**DOCUMENT 00 90 01
ADDENDUM #3**

Project: Provo City Airport Pump Station PROVOENG202320542

Date: Friday, December 2, 2022
Bid Date: Thursday, December 15, 2022
Bid Time: 10:00 a.m.

PROJECT NUMBER: 2019-0033
 SHEET OF: 36 OF 411
 SHEET NUMBER: E402

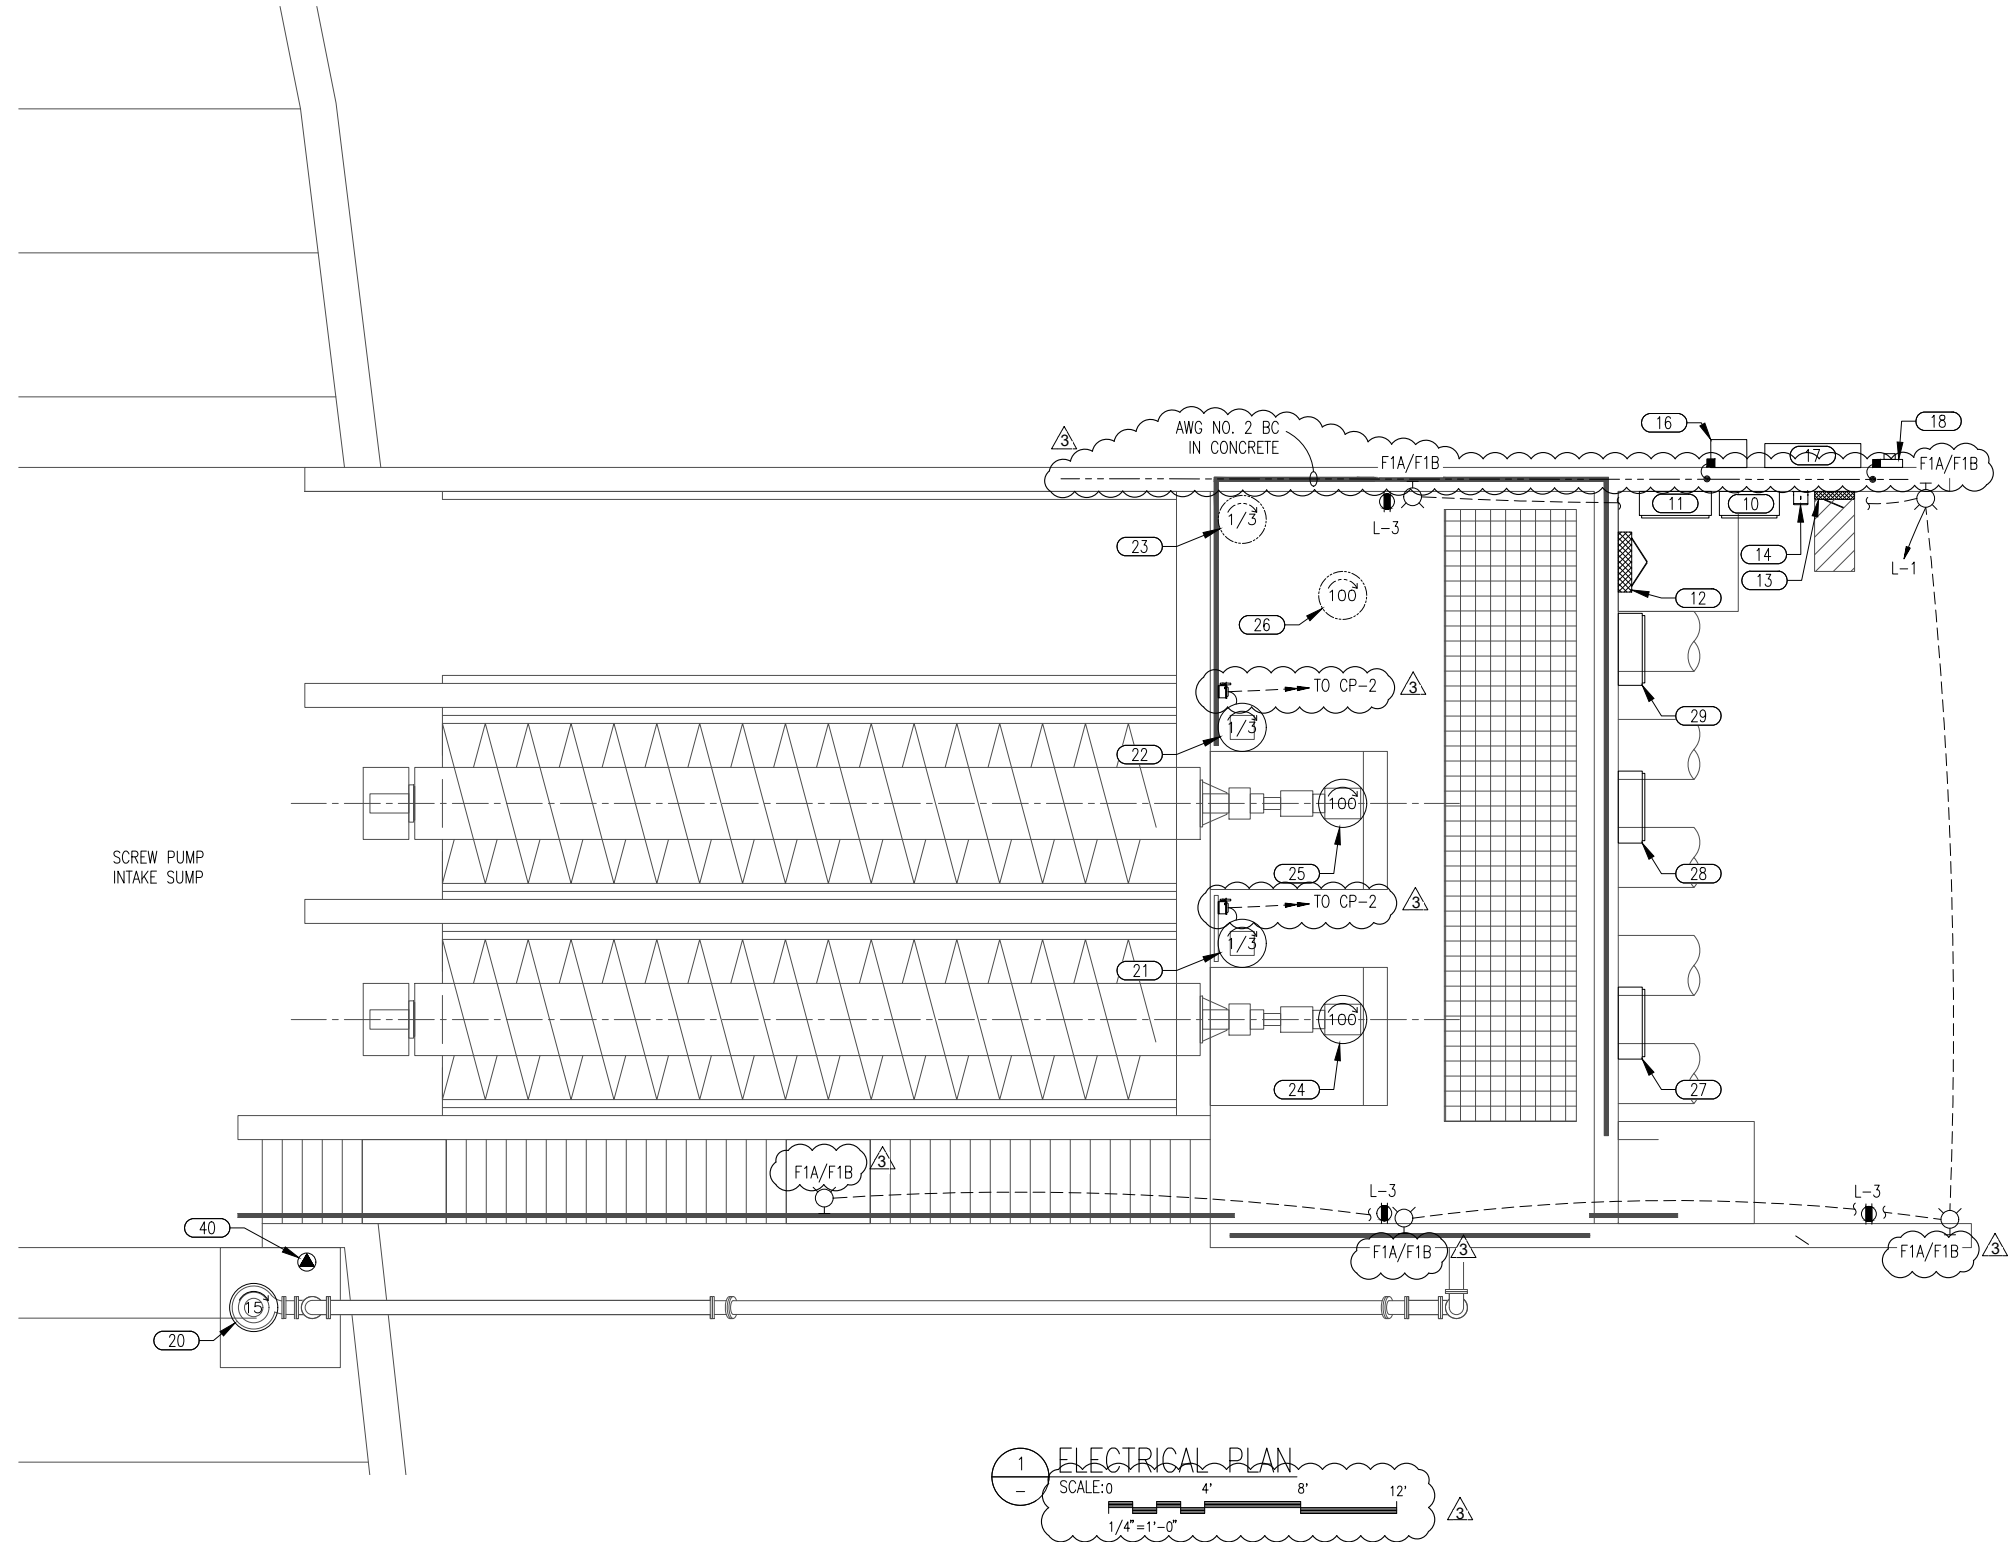
Delete and replace this sheet. Add electrical conduit to be sent to CP-2. Electrical conduits from Main Service Disconnect and Utility Meter.
